GULF STATES UTILITIES COMPANY

May 22, 1985
RBG - 21090
File Code: G9.5

River Bend Station - Unit 1
Docket No. 50-458

Provided for your information are Gulf States Utilities Company (GSU) Final Safety Analysis Report (FSAR) changes that were identified during GSU's indepth review of the River Bend Station Technical Specifications. These changes are provided to ensure consistency between the Technical Specifications and the FSAR.

Figure 4.3-15 RIVER BEND STATION - FSAR
DYNAMIC MODERATOR VOID REACTIVITY
COEFFICIENT AS A FUNCTION OF PERCENT
VOIDS AT END-OF-CYCLE

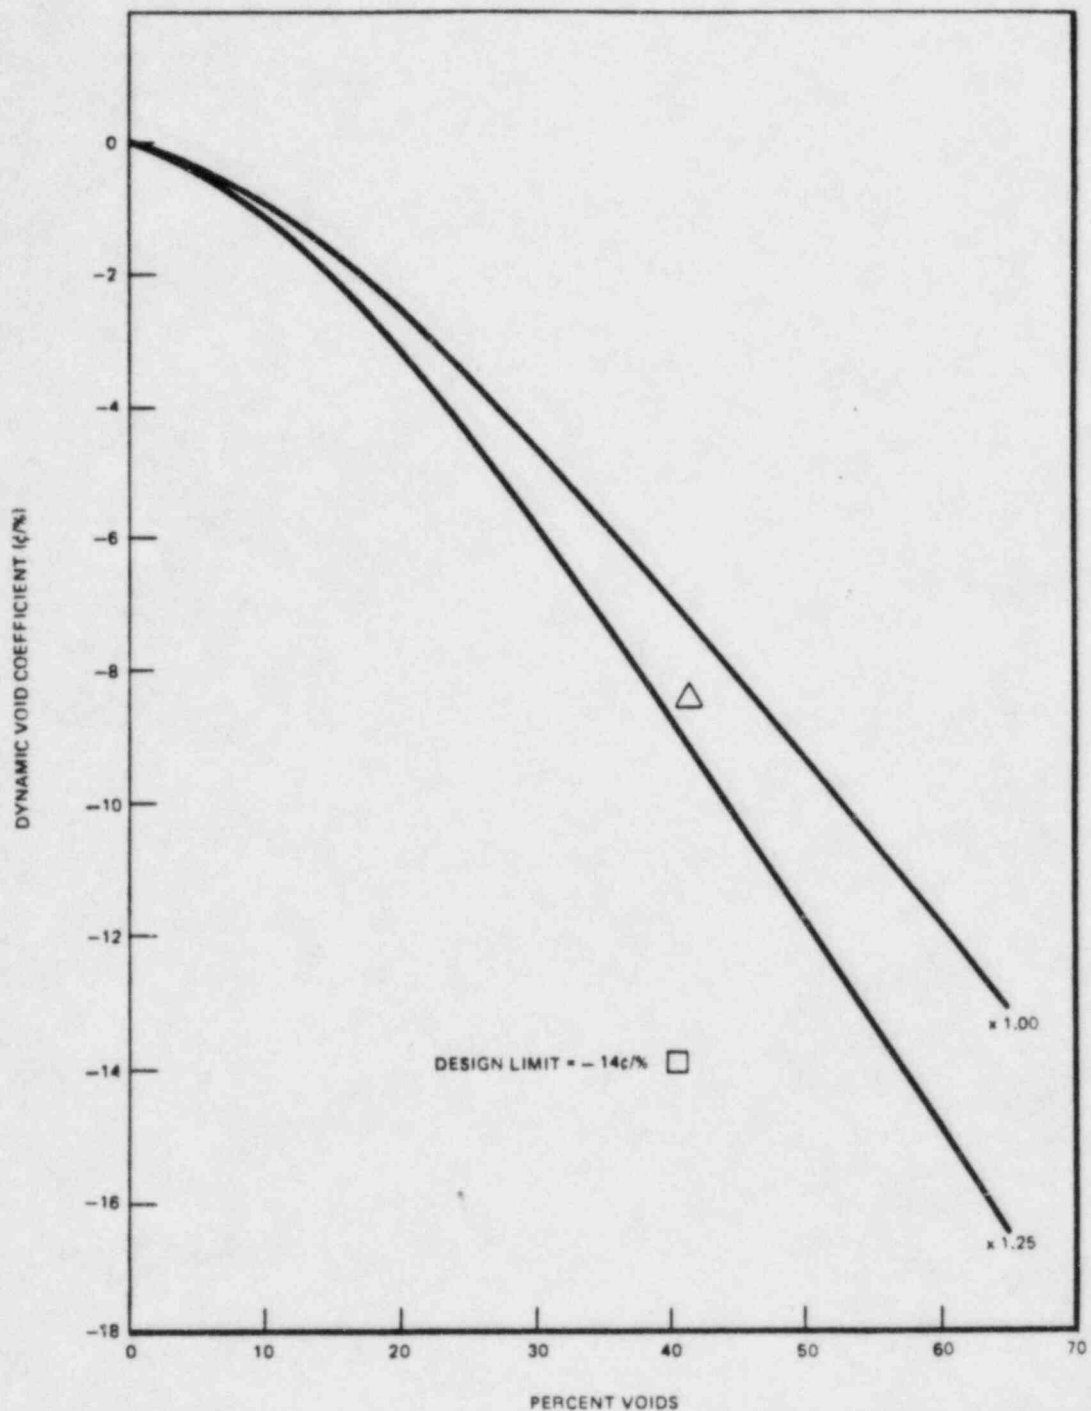
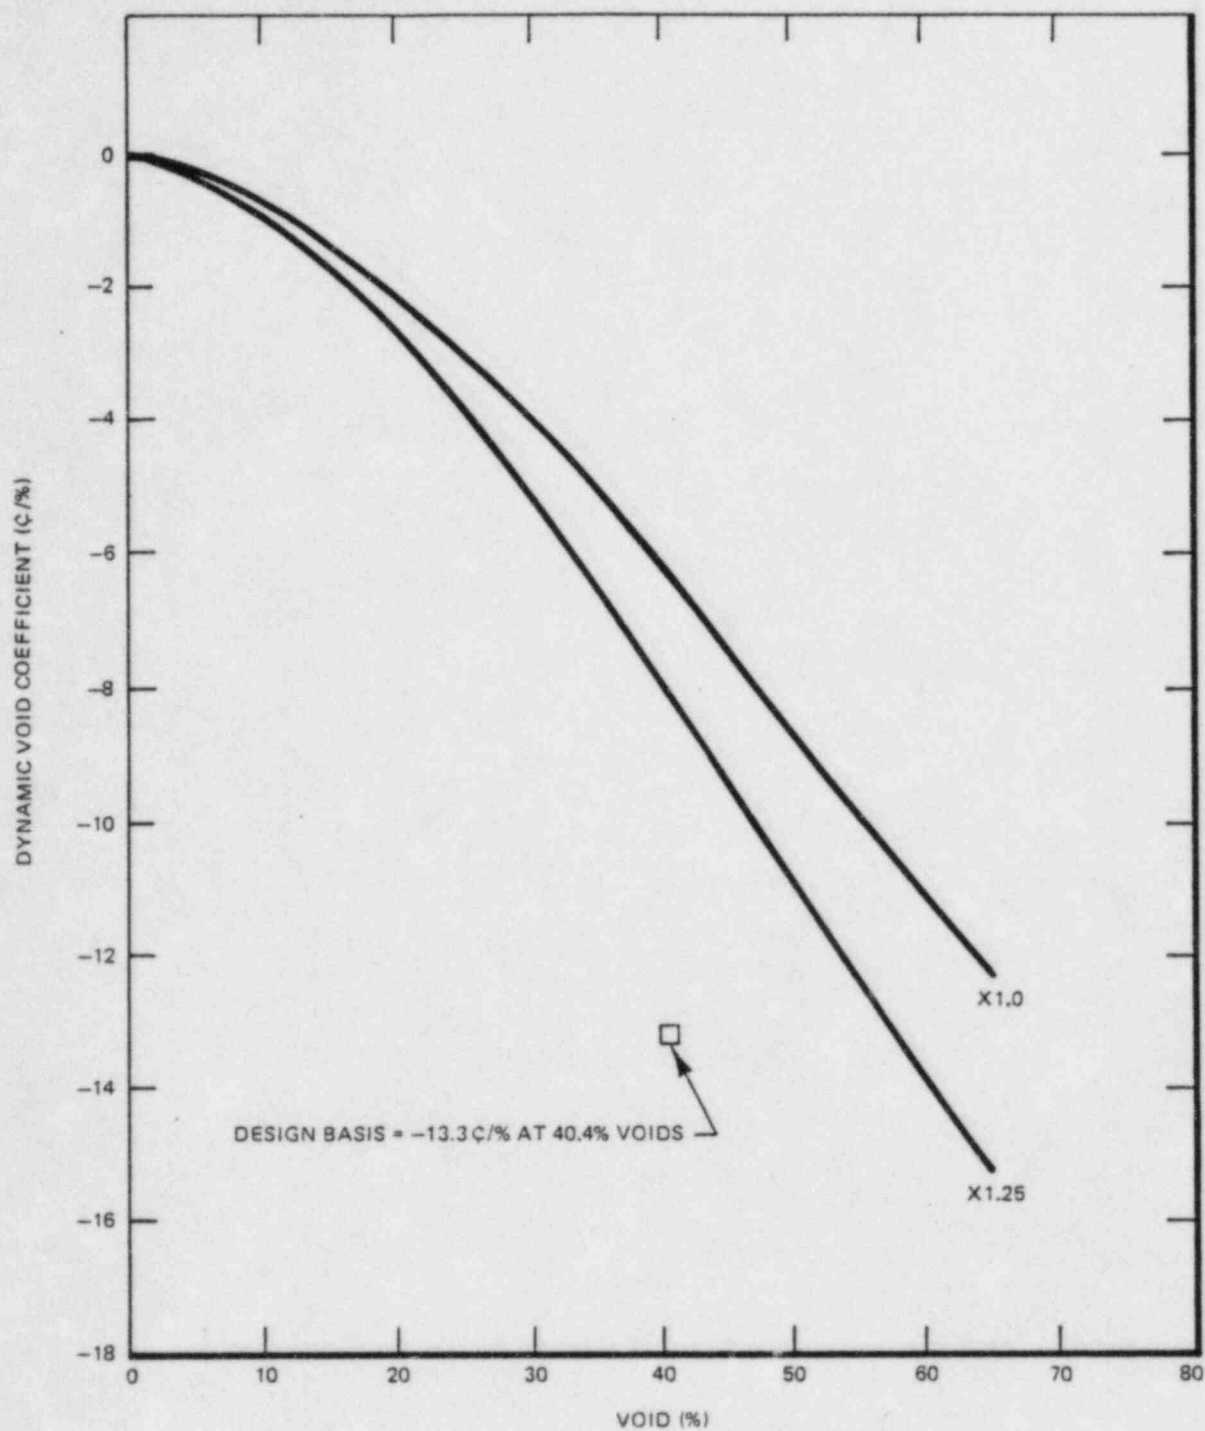
Replace with
attached

Figure 4.3-16 RIVER BEND STATION – FSAR
DOPPLER REACTIVITY COEFFICIENT AS A
FUNCTION OF AVERAGE FUEL TEMPERATURE,
HOT OPERATING, END-OF-CYCLE-ONE

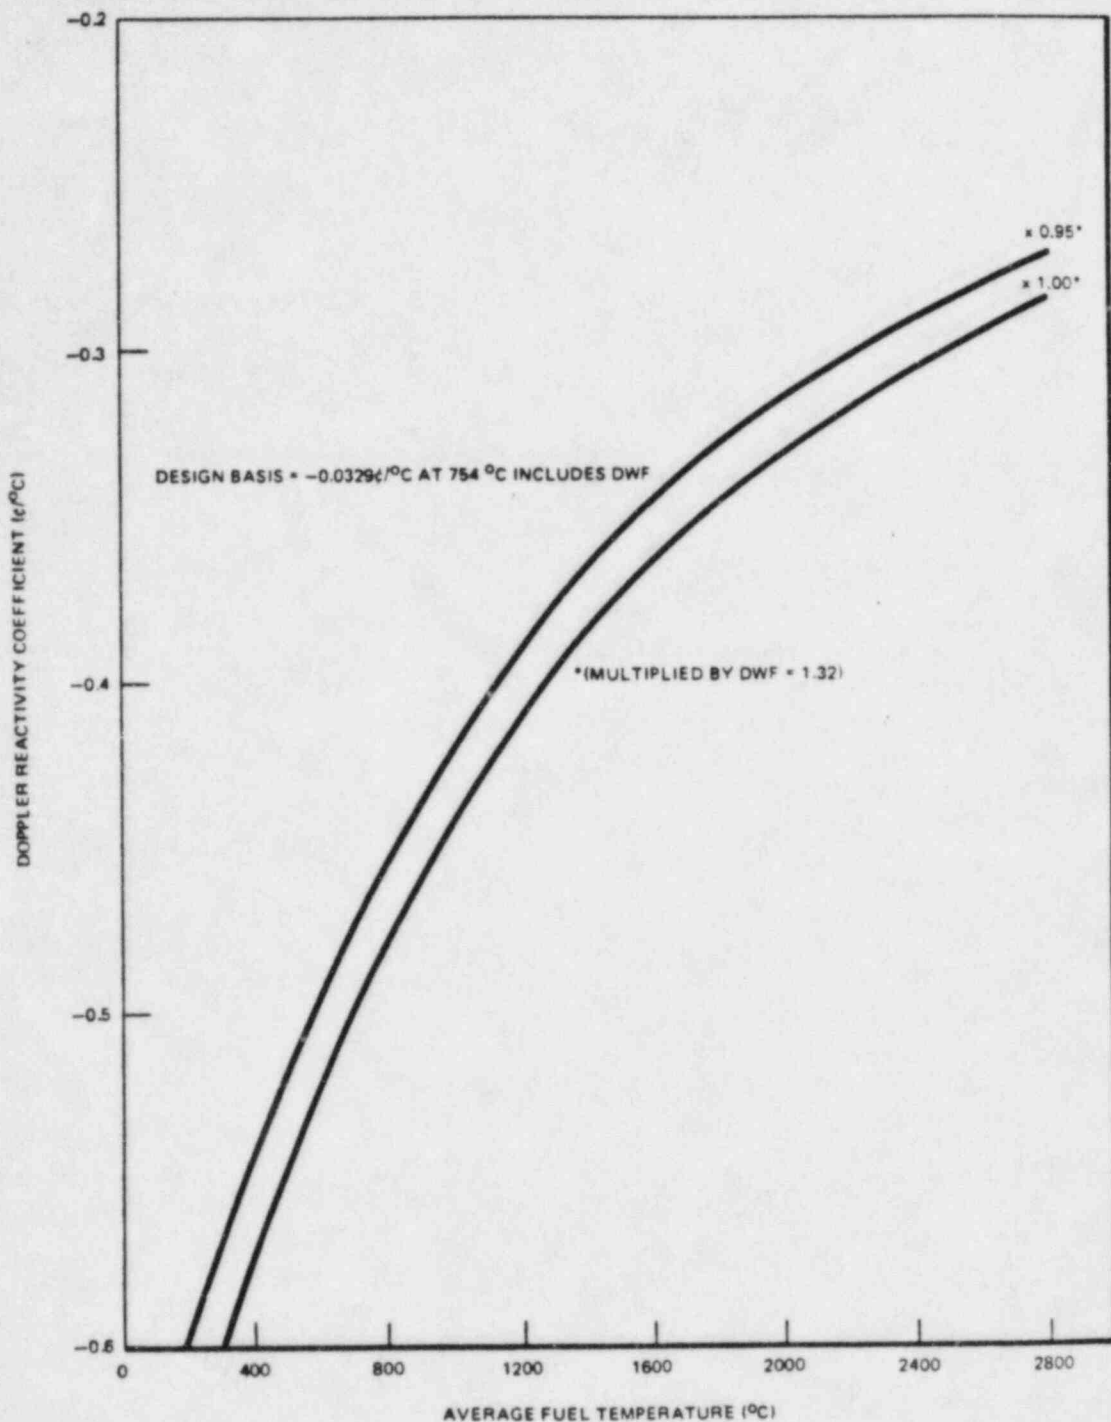
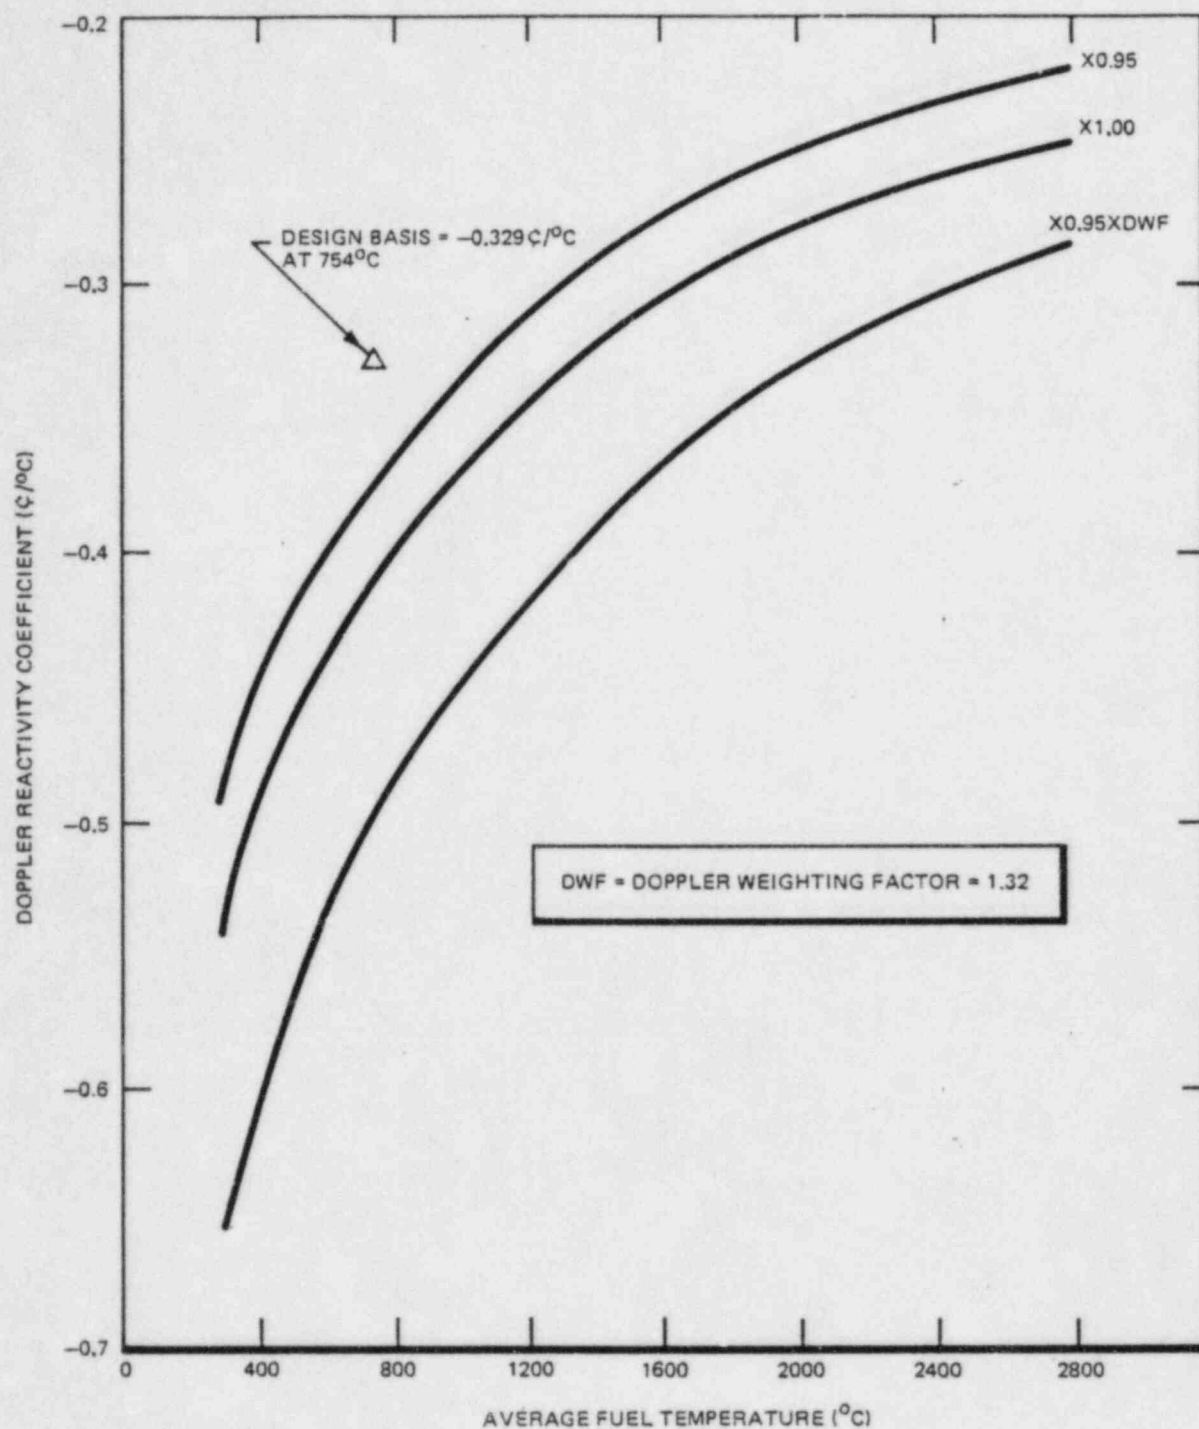
Replace with
attached

Figure 4.3-17 RIVER BEND STATION – FSAR
COLD SHUTDOWN MARGIN AS A
FUNCTION OF EXPOSURE; STRONGEST
ROD WITHDRAWN, NO XENON

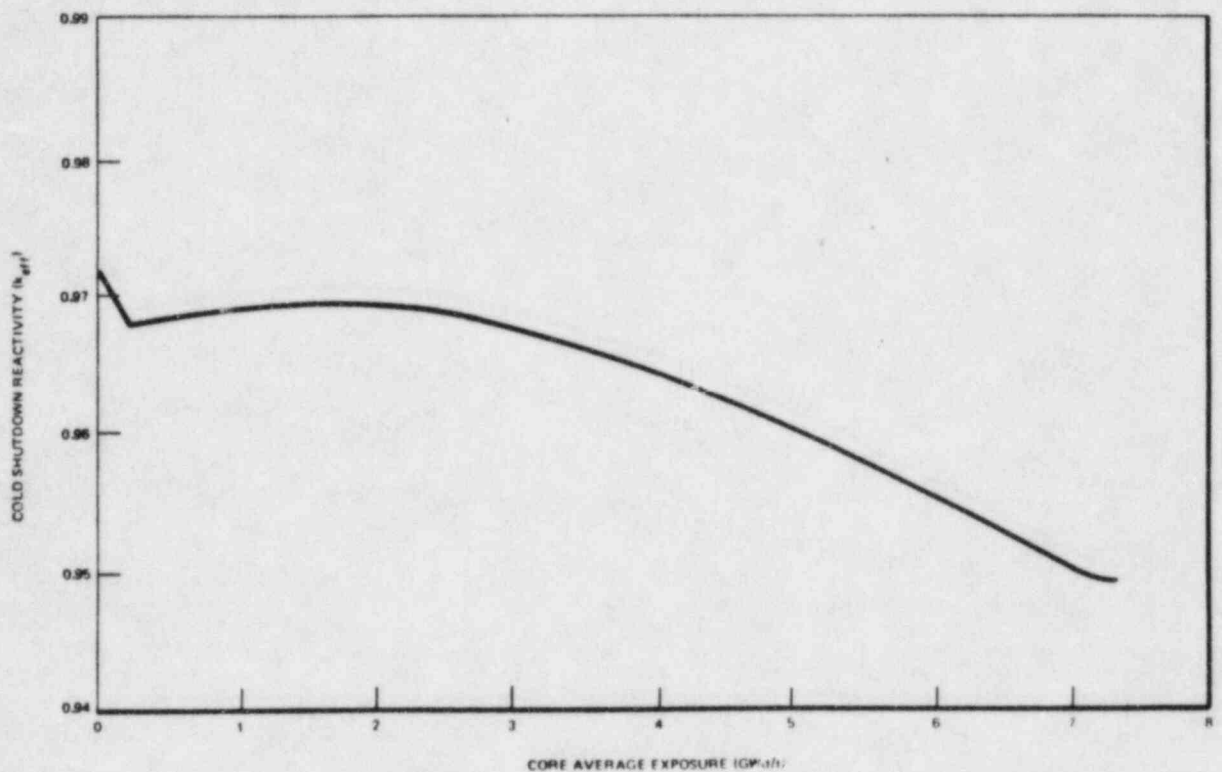
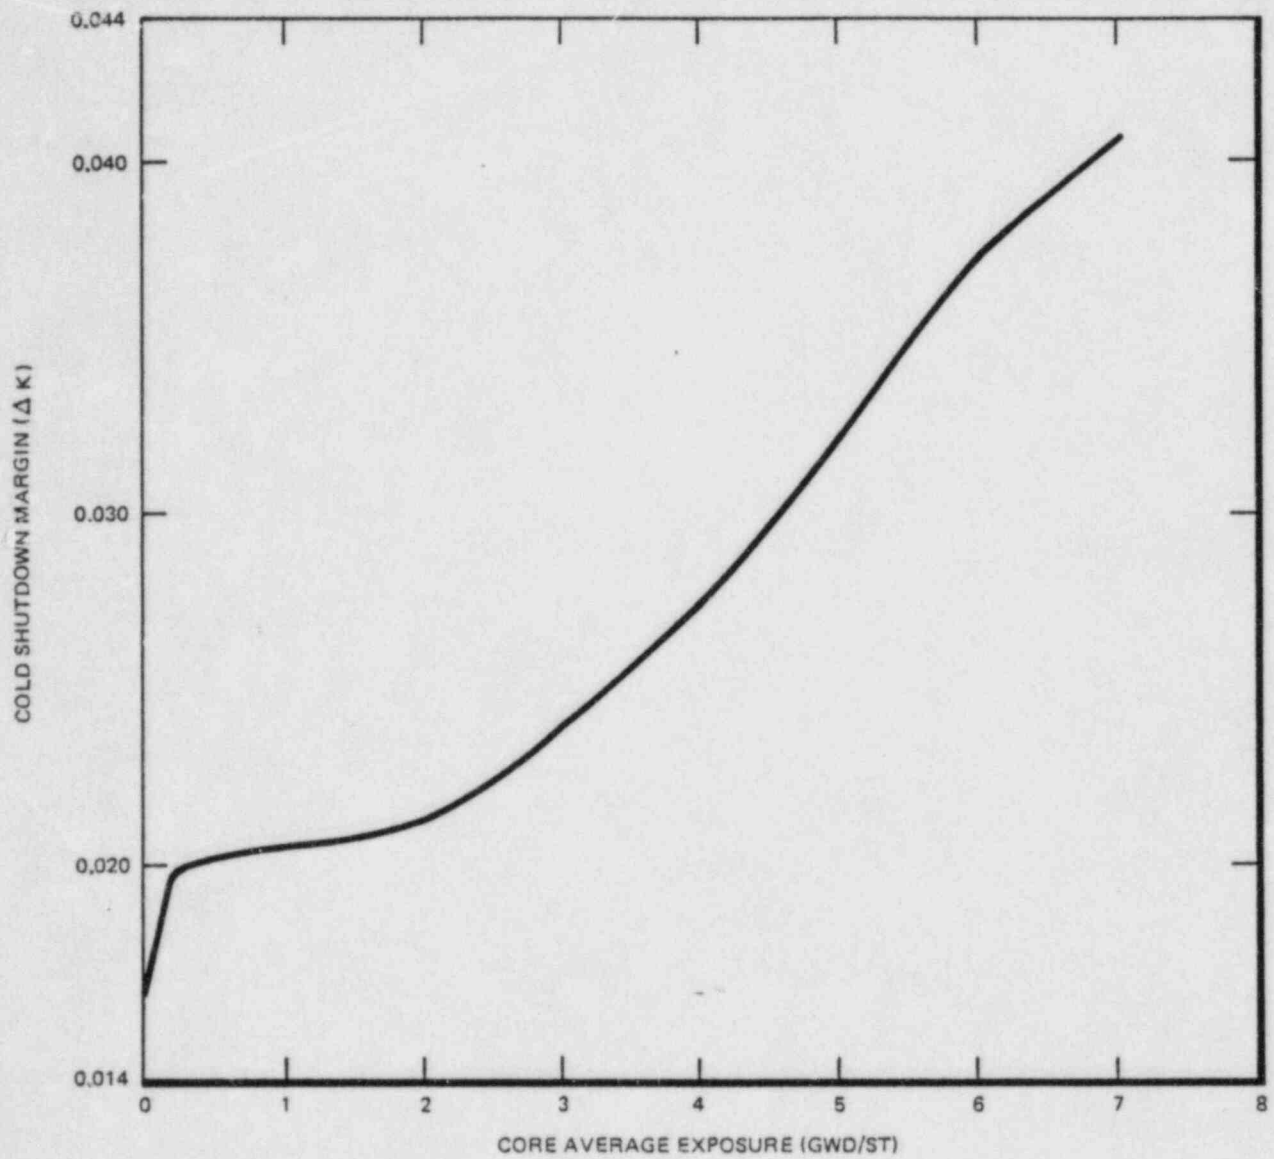
Replace with
attached
